Re: Sunoco Pipeline L.P. – Pennsylvania Pipeline Project (Mariner East II)
DEP File No. E23-524
Technical Deficiency Response
Major Modification – Installation Method Change at 0620 HDD
APS No. 879056, AUTH ID 1087492
Middle Township
Delaware County

Comments and Responses to May 27, 2020 Technical Deficiency Letter Regarding “April 2020 Technical Deficiency Comments of March 25, 2019, Amendment Request”.

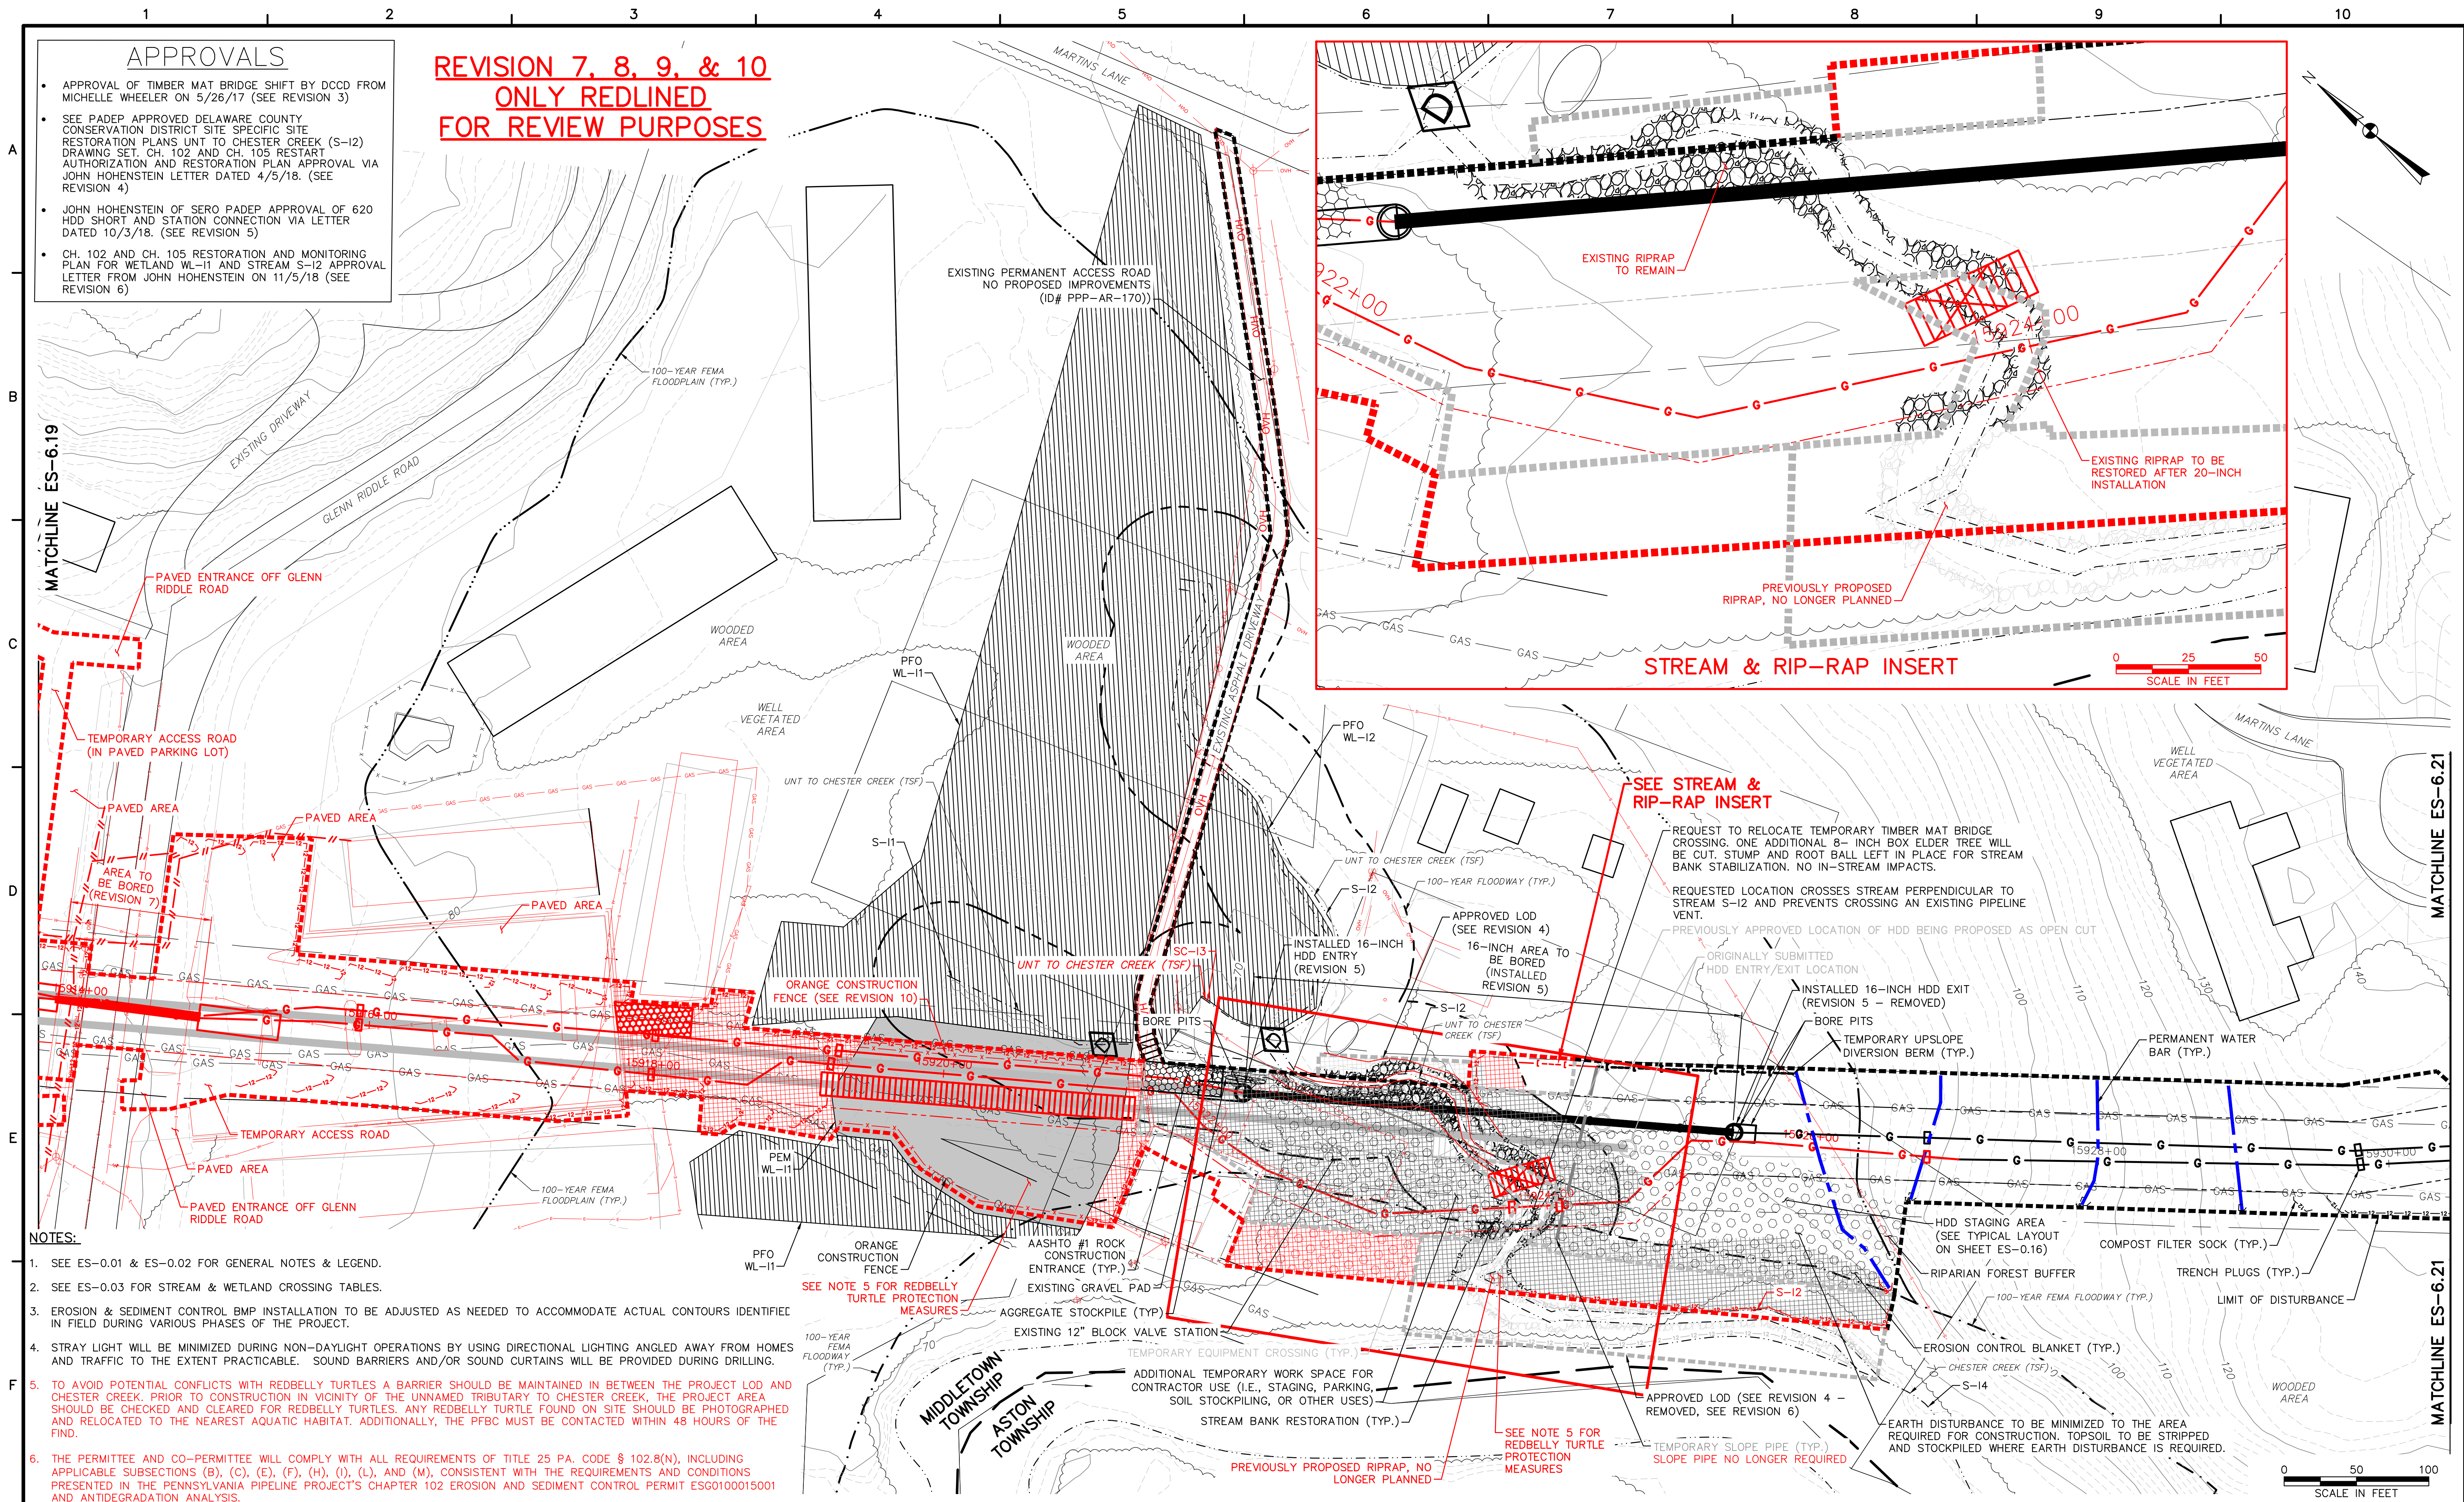
immediately abuts the PEM portion. TT states that there will be no impacts to the PFO portions and requests increasing the width of the LOD from 50 feet to 110 feet due to “hot lines” in the work area. If the LOD is widened, then it appears that impacts will occur to one or both of the PFO portions of WL-I1. Address this issue, including an explanation of the “hot lines” and associated safety issues and fully explain the reasons why the width of the LOD should be extended.

Response: Sheet ES-6.20 of the Erosion and Sediment Control & Site Restoration Plan presented in *Attachment D* of the permit modification application has been revised to include orange protective fencing along the boundaries of wetland WL-I1. The revised sheet is included in **Attachment II** of this response.

Response: The impact width will be a maximum of approximately 110 feet. Where the area between the western and eastern PFO areas narrows, the impact also narrows to 60 feet and remains within the PEM wetland classification. This irregular shape of the impact is depicted on the E&S Plan sheet ES-6.20 included as *Attachment D* of the permit modification application and included in **Attachment II** of this response.
